Project: 226052 DFCI-BIDMC New Cancer Hospital - 1 Joslin Place - Construction
1 Joslin Place
Boston, Massachusetts 02215

RFI #0-PB-31: Vault North Slab Edge Location

S1.00

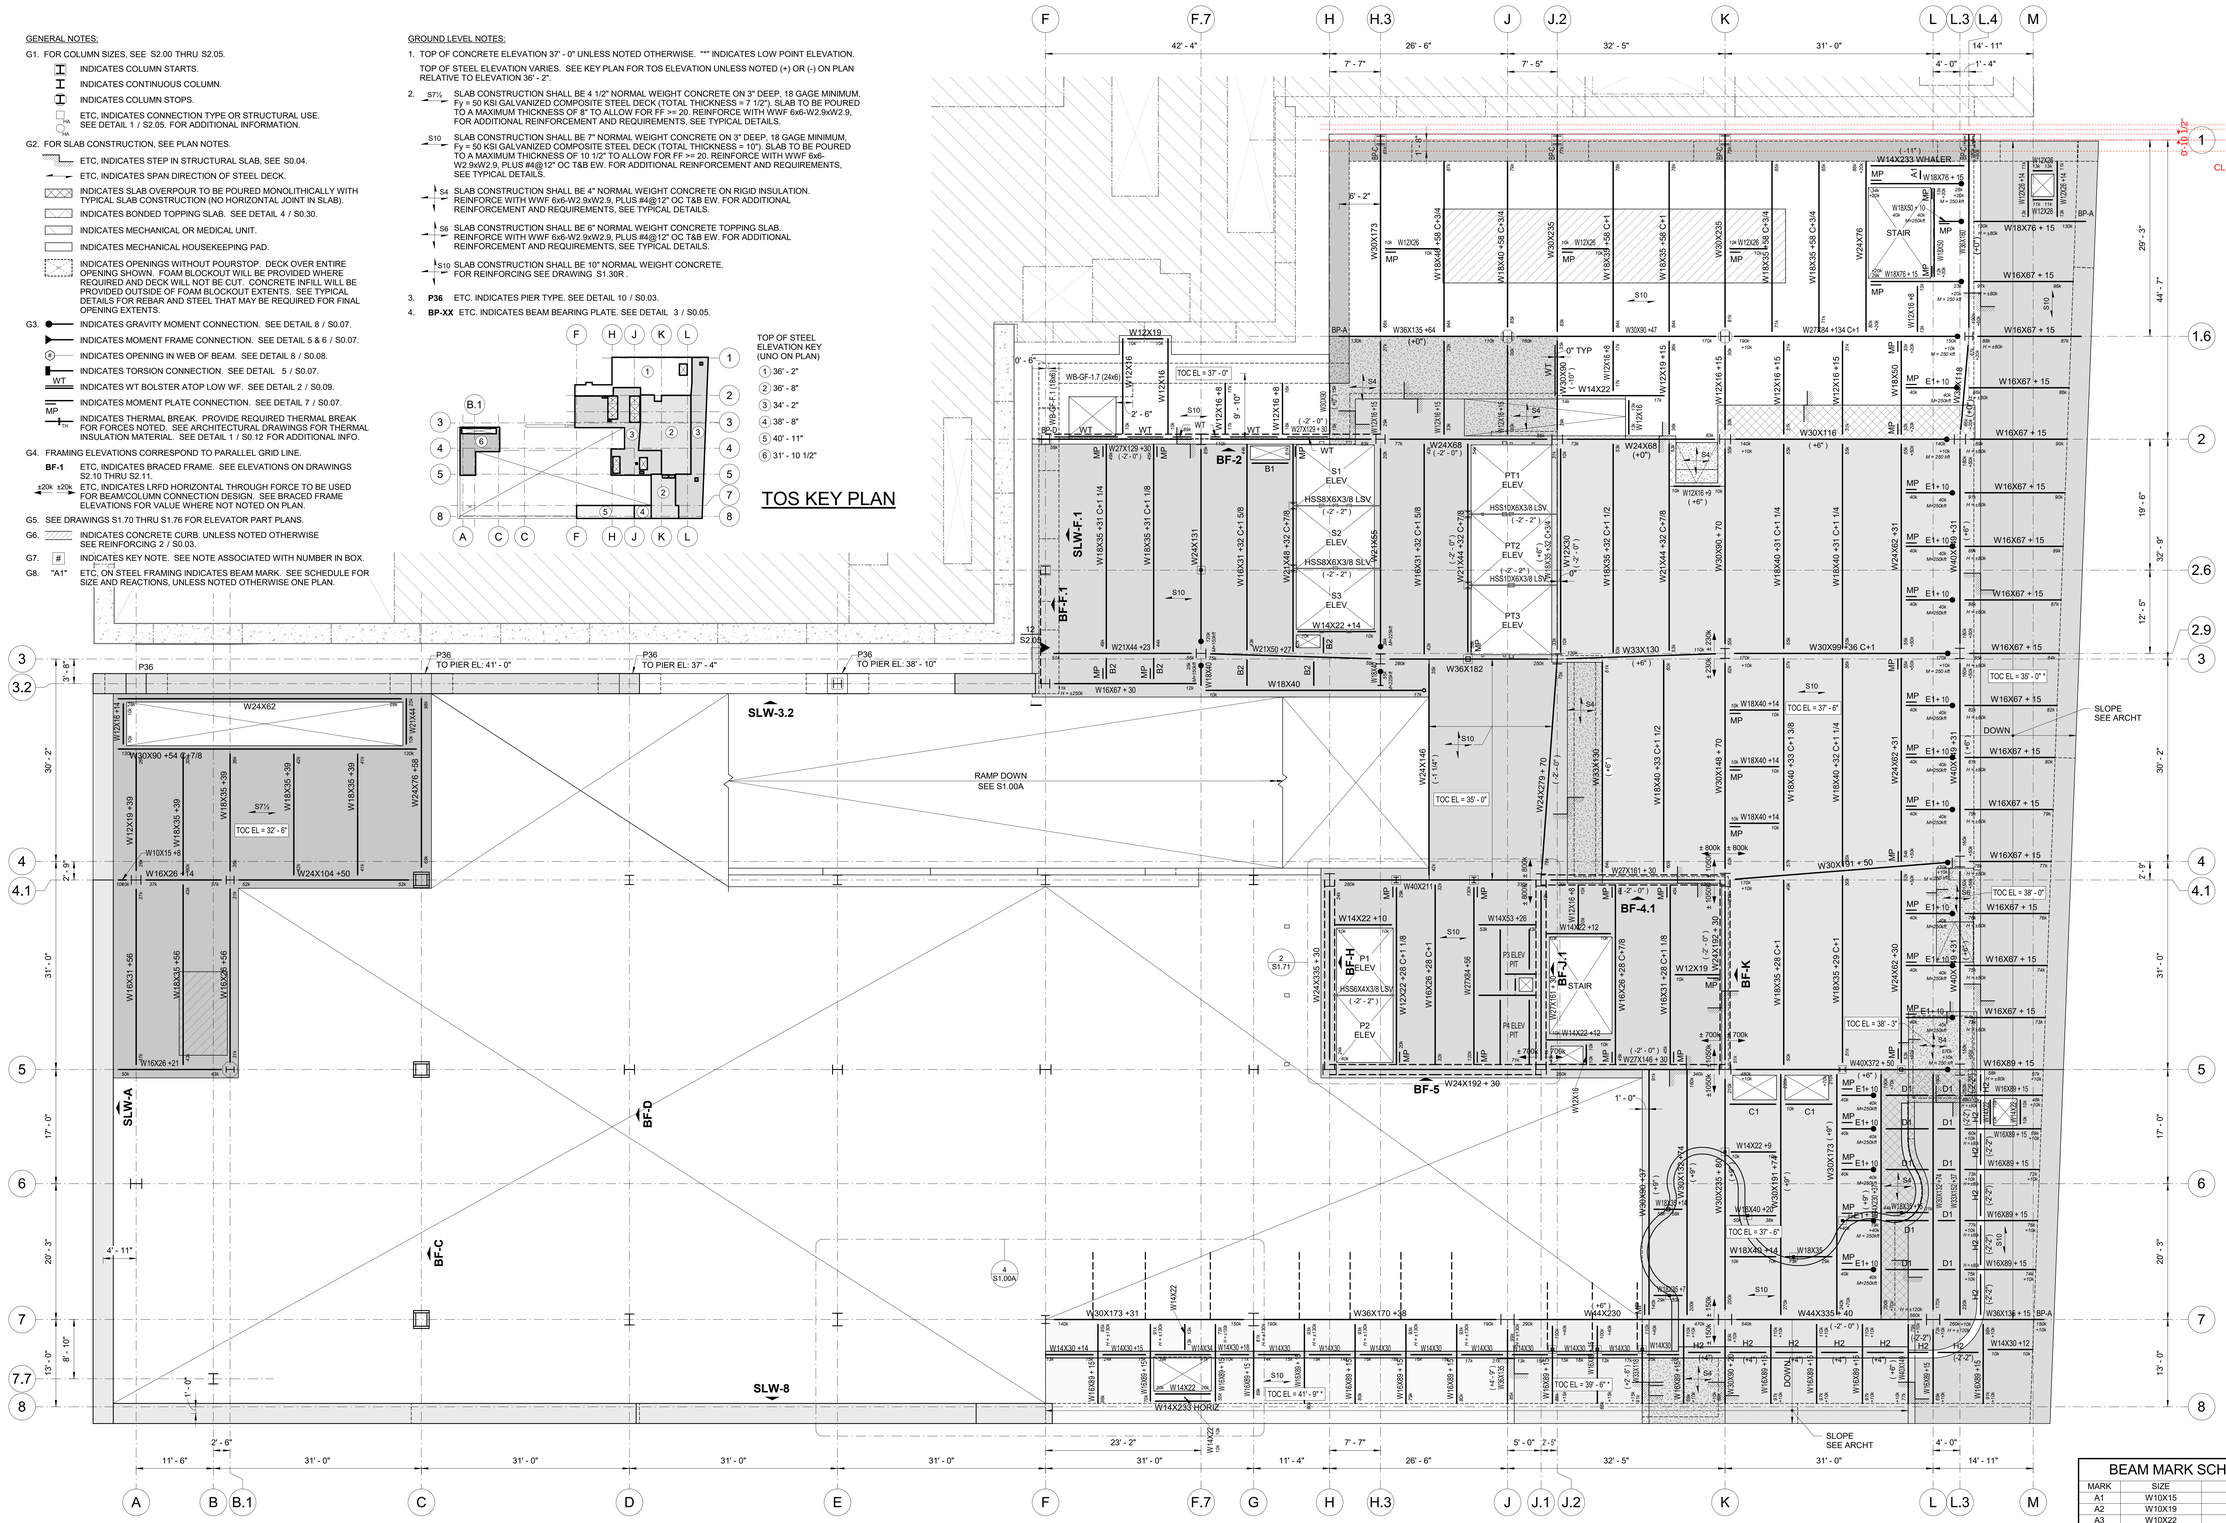
The ground level north slab edge between column lines H-1 and L.4-1 is shown at varying distances north of column line 1. The slab edge distance north of column line 1 is:

- 2’-3” per A1.00
- 1’-7” per 1/A8.70A
- 10-5/8” per S1.00, 1/S3.11, 4/S5.10.

The slab edge on Level 2 above is shown 1’-7” north of column line 1 per both architectural and structural. Please clarify the ground level slab edge location. Please advise if any structural changes are required based on the confirmed location.

Per Payette 11/14 response: The Ground Level north slab edge between column lines H-1 and L.4-1 shall match Level 2, which is 1'-7" north of Column Line 1.
This change will be captured on Architectural and Structural slab edge drawings in the 1/15 Addendum.
